TO: All Dealers and installers

Date: 04/20/2015

SUBJECT: Service Bulletin #042015CS- 2015 PCM Reflash Update
2015 Ford Mustang GT vehicles with ROUSH® Supercharger retail kit installation completed on or before April 1, 2015

APPENDIX A

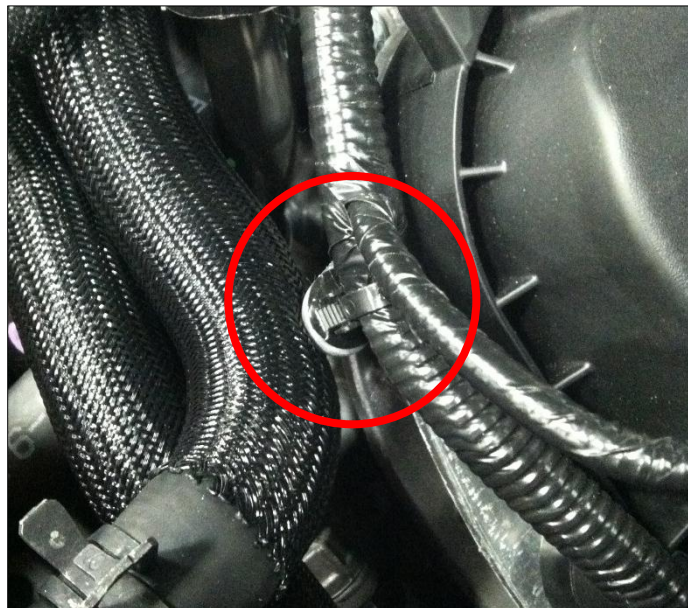
Modification to front cover to improve clearance to intercooler hose.

Step 1 – Locate the wiring retention tab on the front cover in front of the driver side cam cover. Using a trim tool, remove the wire harness retainer from the tab.

Step 2 – Retain the harness and hose aside and using a suitable cutting tool (cut off wheel, air saw, etc.) remove the tab from the front cover so it is flush with the edge of the cam cover. Use caution to not cut or damage any of the surrounding components.

Step 3 – Using a suitable grinding tool (Air Grinder, hand file) remove any burrs and sharp edges. Remove the wiring harness push pin retainer from the wire harness.
